Access Compliance Report

Public Rights-of-Way

(Curb Ramps)

Intersection ID: 53504	Main Street: CRIPPLE_CREEK_LN	Cross Street: ALLISON_LN	Location: NE
ADA ID: 534B59607042	Ramp Type: Combination1	Initial Pass/Fail: Fail	Overall Compliance: No
			Severity Score: 46.25

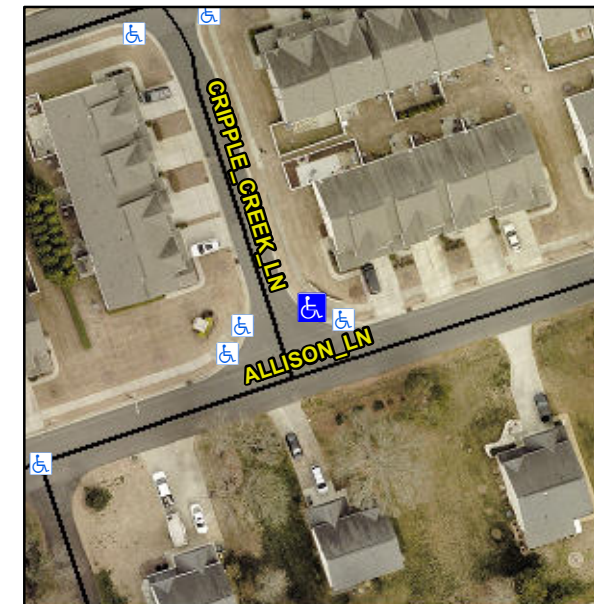
Not Found, R304.5.1, R304.2.2, R304.5.3

Compliance	Description	Data	Compliance	Description	Data
N/A	Ramp Length LT (in)	51.0	N/A	Ramp Length RT (in)	44.0
No	Ramp Width LT (in)	44.0	No	Ramp Width RT (in)	47.0
Yes	Ramp Slope LT (%)	6.5	Yes	Ramp Slope RT (%)	8.0
No	Ramp XSlope LT (%)	2.8	No	Ramp XSlope RT (%)	3.1
N/A	Ramp Length (in)	58.0	No	Ramp Slope (%)	12.1
Yes	Ramp Width (in)	48.0	No	Ramp XSlope (%)	6.5
N/A	Flare Type LT	N/A	N/A	Flare Type RT	N/A
N/A	Flare Slope LT (%)	N/A	N/A	Flare Slope RT (%)	N/A
N/A	Flare Traversable LT?	N/A	N/A	Flare Traversable RT?	N/A
N/A	Landing Length (in)	N/A	N/A	DWS Provided?	N/A
N/A	Landing Width (in)	N/A	N/A	DWS Contrast?	N/A
N/A	Landing Slope (%)	N/A	N/A	DWS Length (in)	N/A
N/A	Landing X Slope (%)	N/A	N/A	DWS Full Width?	N/A
N/A	Landing Curb? (Y/N)	N/A	N/A	DWS Offset (in)	N/A
N/A	Shared Landing?	N/A			
N/A	Gutter Ponding?	N/A	N/A	Gutter Slope (%)	N/A
N/A	Gutter Lip Ht (in)	N/A	N/A	Gutter X Slope (%)	N/A
N/A	Painted X Walk1?	No	N/A	Painted X Walk2?	N/A

Remove & Replace Entire Ramp.
